**Audubon
California**

February 23, 2015

RE: Comments re the Draft California Desert Renewable Energy Plan and Associated Environmental Impact Statement/Environmental Impact Report (EIS/EIR)

Figure 19.1. Locations of male Burrowing Owl territories in the 2007 and 2008 breeding seasons, determined from 3 point-coordinate capture-recapture survey occasions in the HCP Study Area, Imperial County, California.

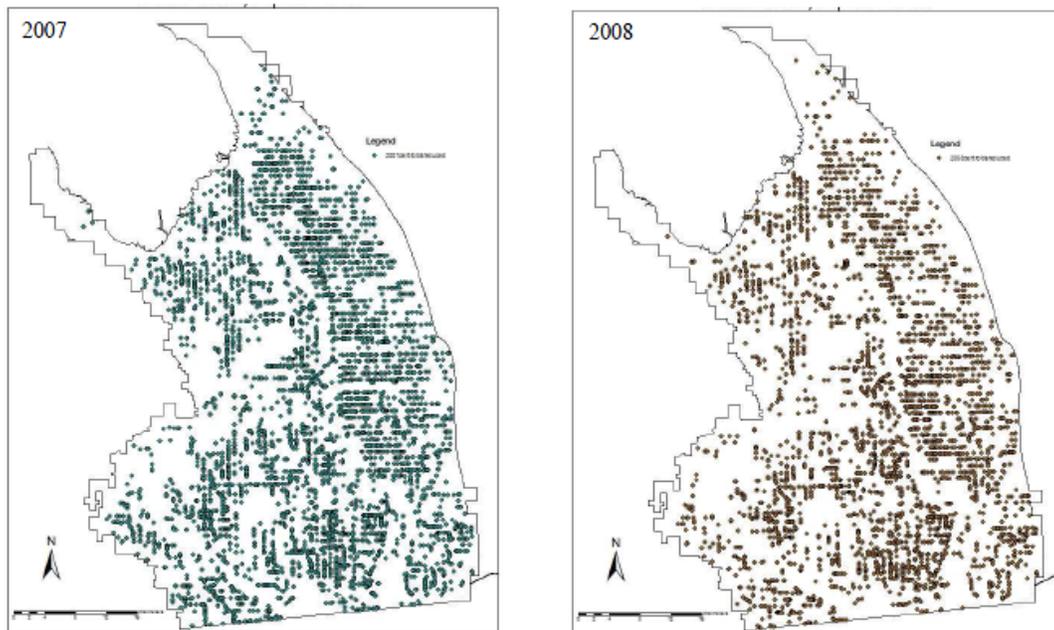
Figure III.7-17 (Covered and Planning Species Occurrence Locations – Imperial Borrego Valley Ecoregion Subarea) is missing many known occurrences of burrowing owls. As one major example, see Figure 19.1 (Manning 2009) for locations of male burrowing owl territories in the 2007 and 2008 breeding seasons:

Audubon has created an online map documenting known occurrences of burrowing owl in the Imperial Valley over the past decade: <http://ca.audubon.org/salton-sea>. All known occurrences that are not currently included in the DRECP DEIR should be added to the document.

Tricolored Blackbirds Colonies within the DRECP Plan Area

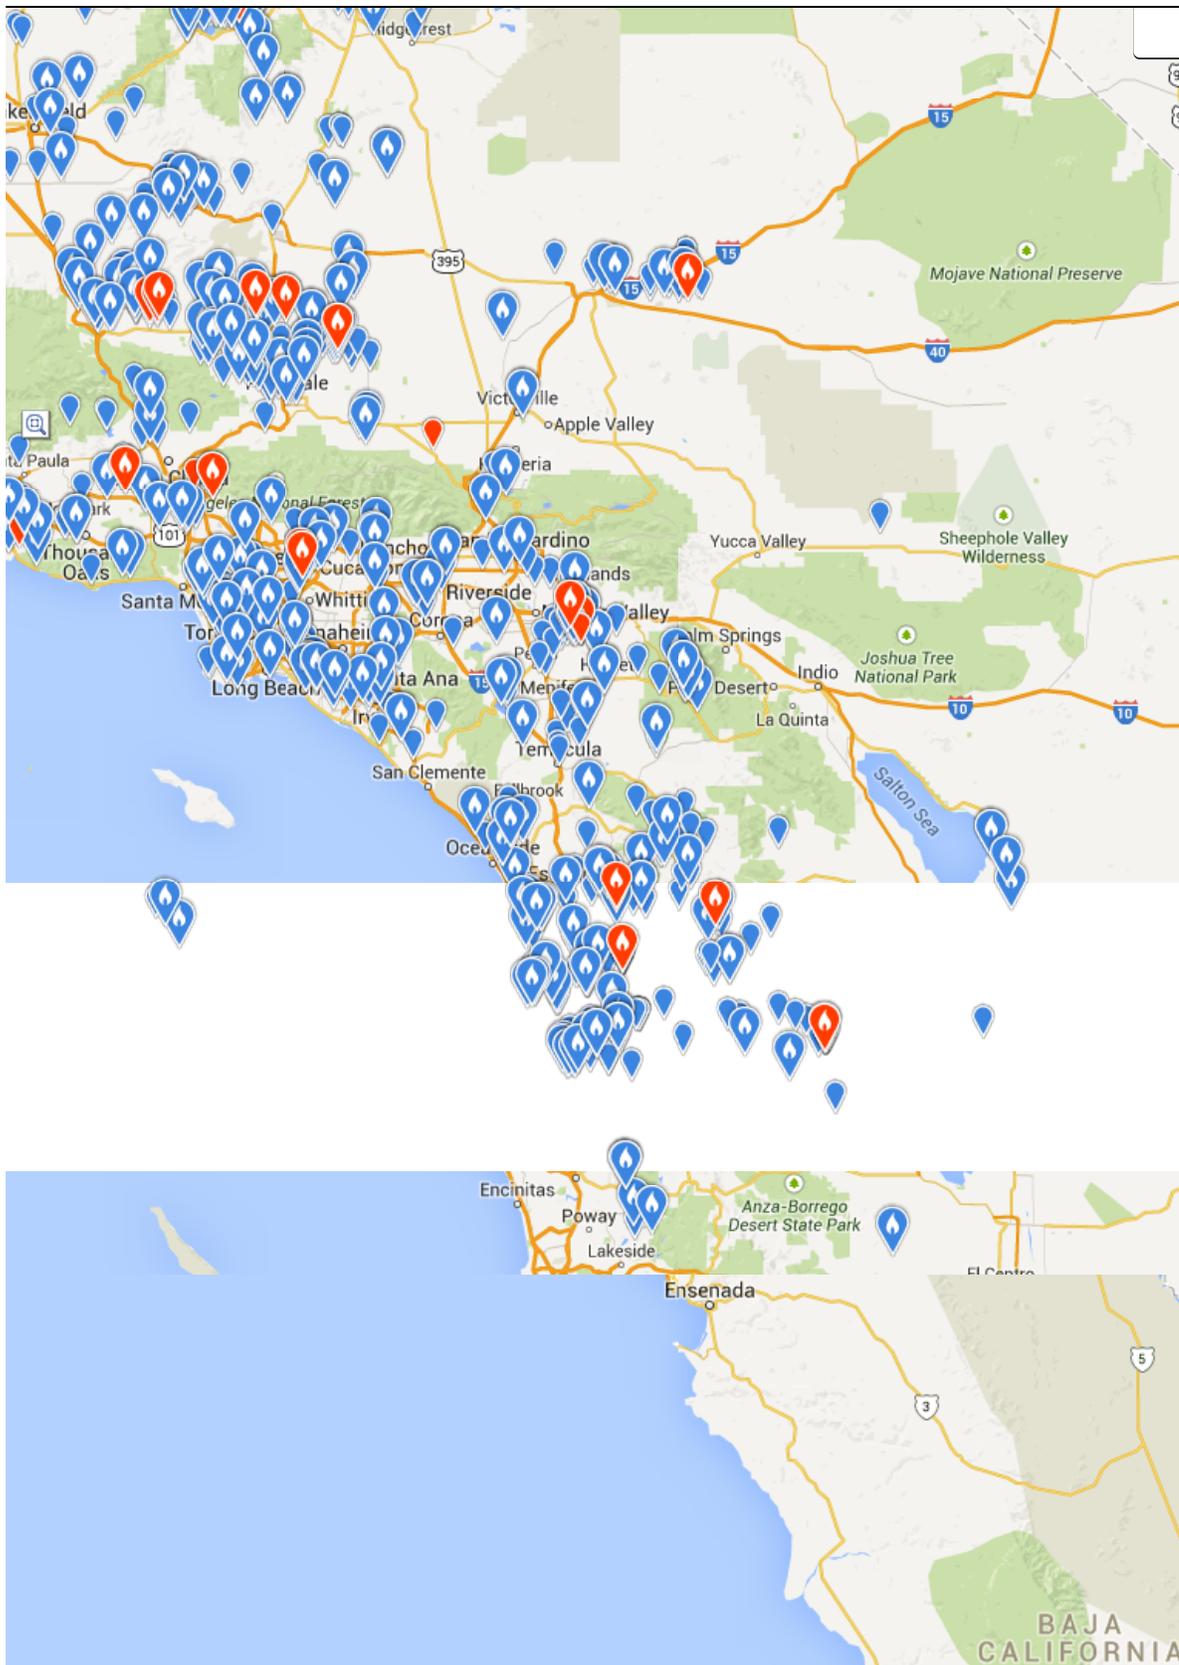
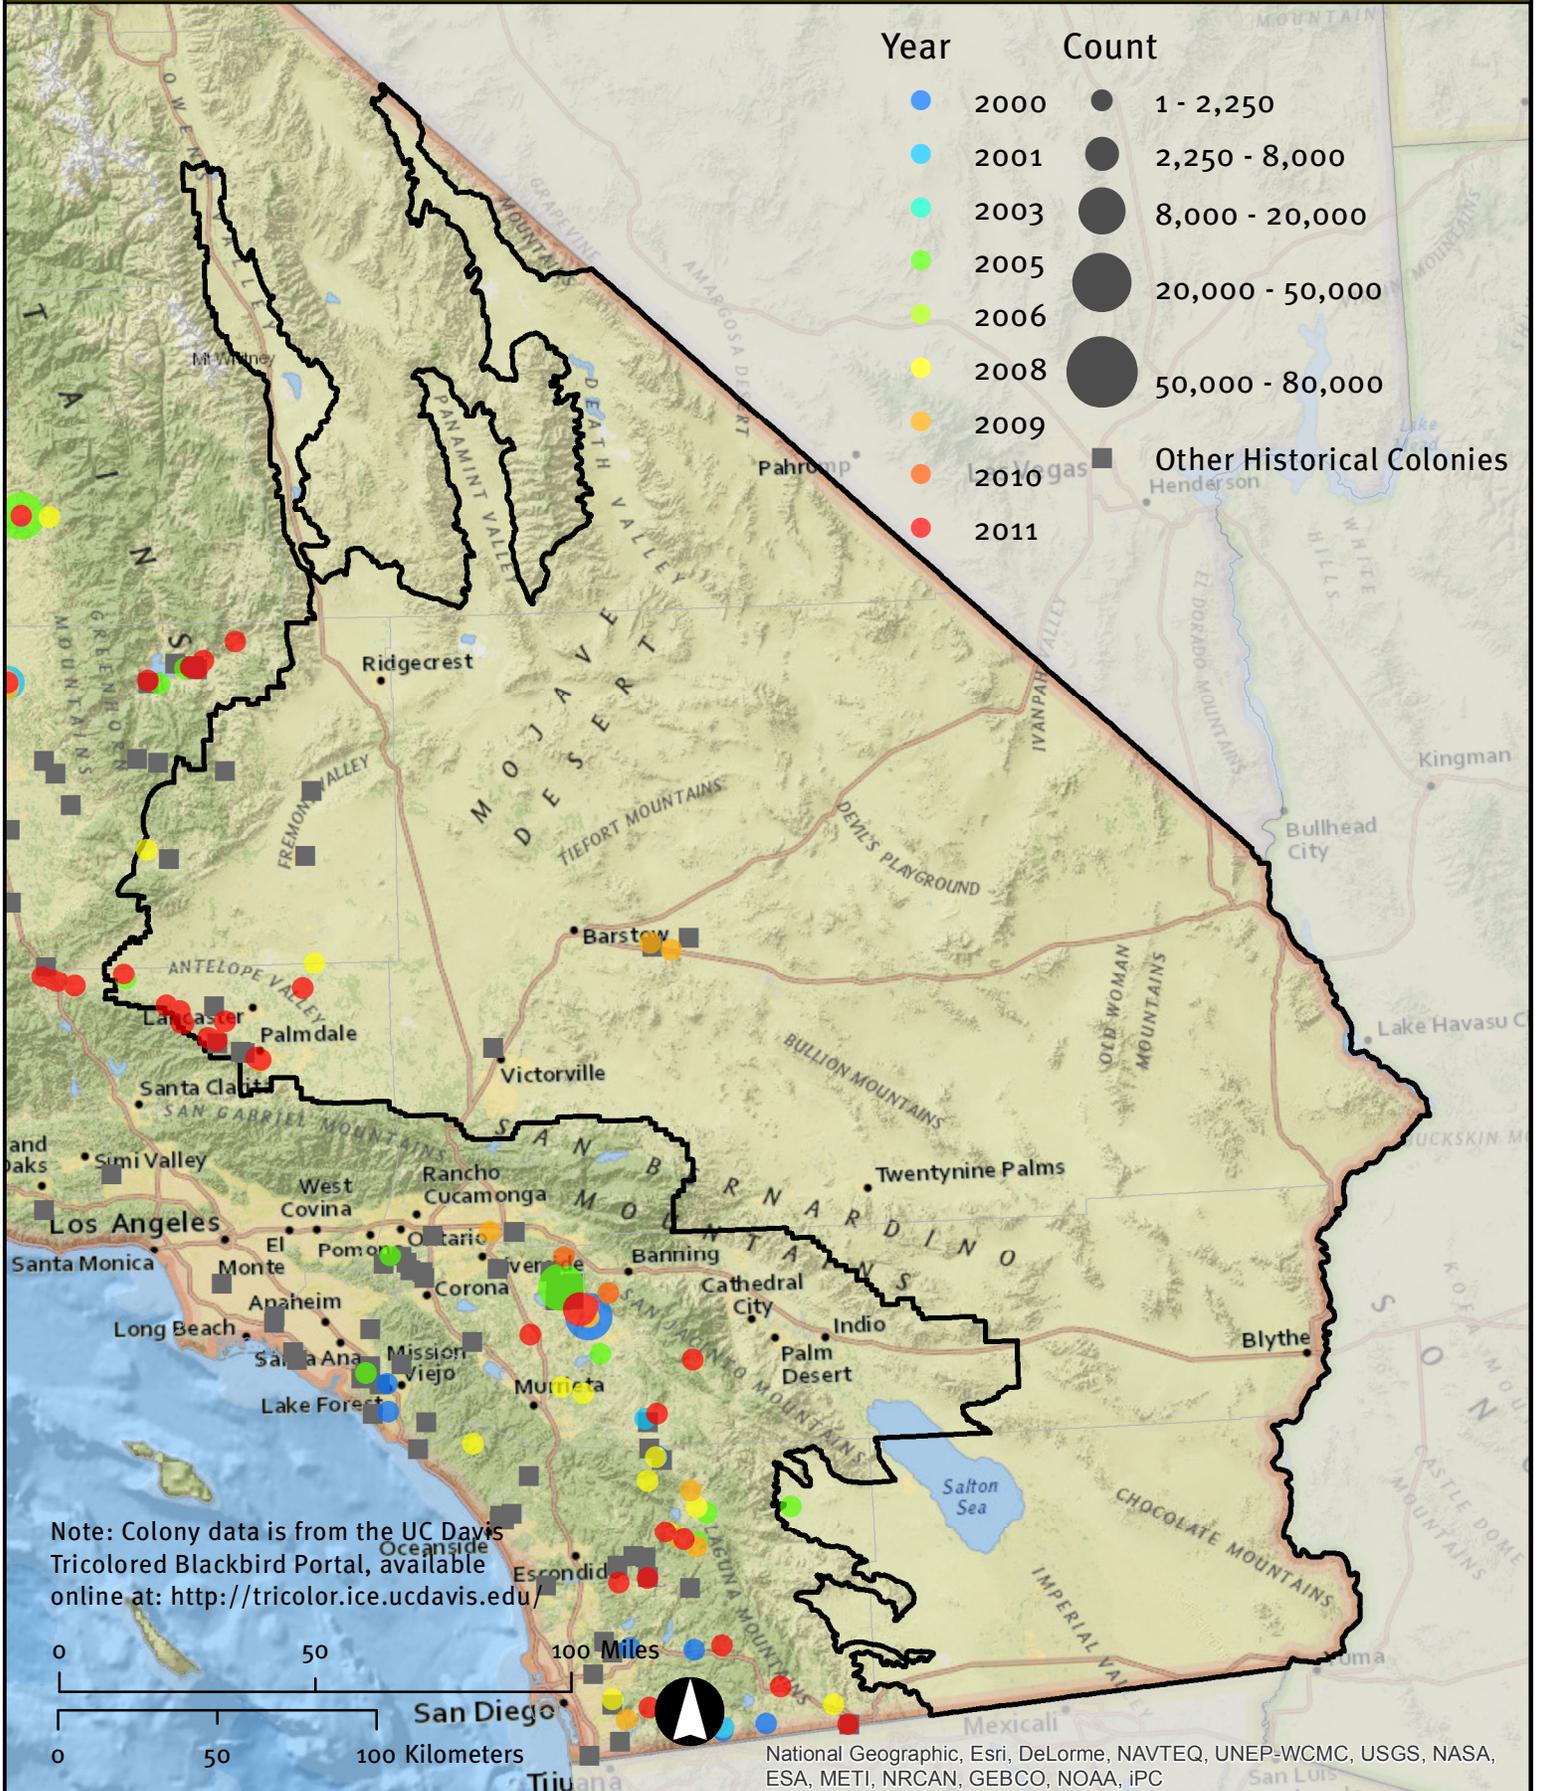
The internet database portal *eBird* appears to provide more data on occurrence of tricolors in the Plan Area (see attachments hereto). Audubon suggests the plan authors review the *eBird* data to determine whether additional occurrences of the tricolor within the Plan Area warrants greater mitigation and conservation measures in the Plan.
